Project Name: Culver's
 Description: Preliminary site plan approval
 Date on Agenda this packet pertains to: May 2, 2024

RE: Culver's- Preliminary Site Plan Review – 2nd Review

RE: Culver's
Preliminary Site Plan – Review #2

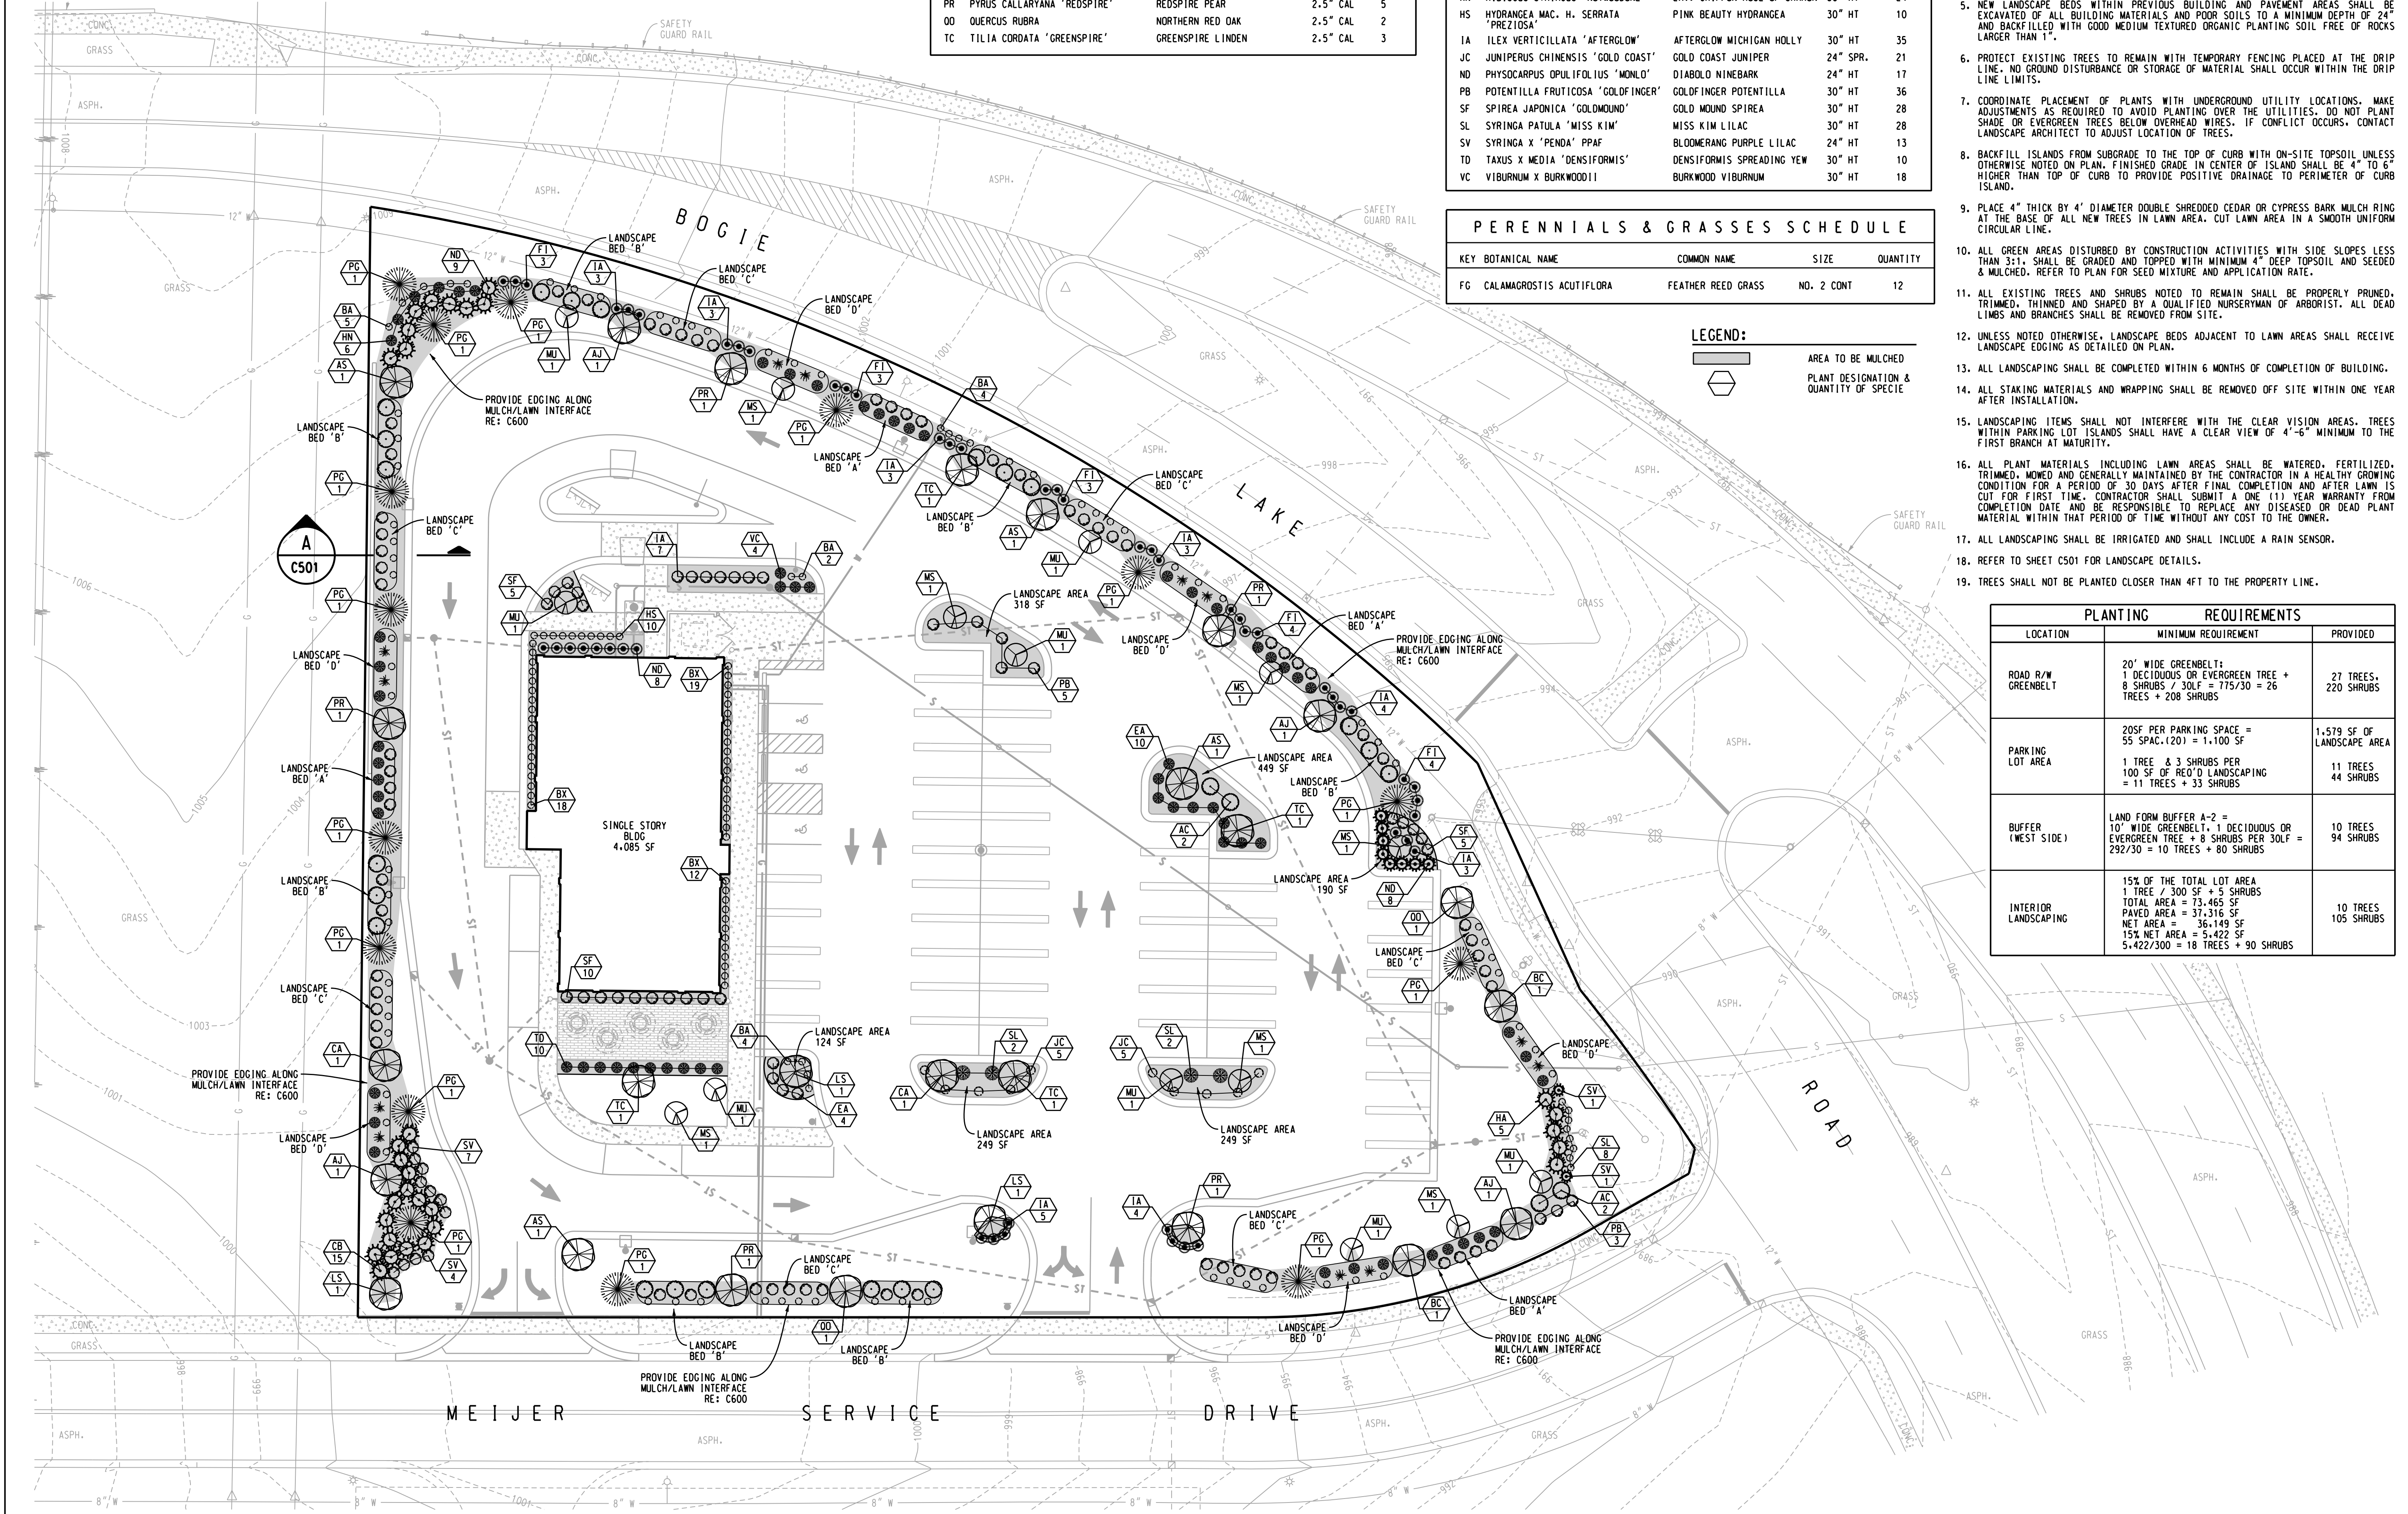
- x) *Sheet C500- There are several locations where proposed trees are shown too close to proposed sanitary sewer, water service, and storm sewer. Please provide a minimum of 10' horizontal separation between trees and these utilities. We have attached a red lined copy of this plan sheet for exact locations. Comment addressed. Landscape plan has now been revised. All proposed trees are now shown a minimum of 10' away from proposed sanitary sewer, water service, and storm sewer.*

- **The Planting Requirements Table on Sheet C500 shall be revised. The minimum requirement listed for the west side buffer is incorrect. A greenbelt 10 feet in width planted with 1 large deciduous or evergreen tree and 8 shrubs for every 30 linear feet is required. Revise accordingly. (Comment partially addressed. While the greenbelt requirement has been added, the following wording still needs to be removed: “Land Form Buffer A-2 =”)**

- **18 trees are required for interior landscaping and 7 trees are proposed. Therefore, a waiver is required. (Comment outstanding. A waiver is required. Note 10 trees are now proposed, so the waiver requested is for eight trees).**
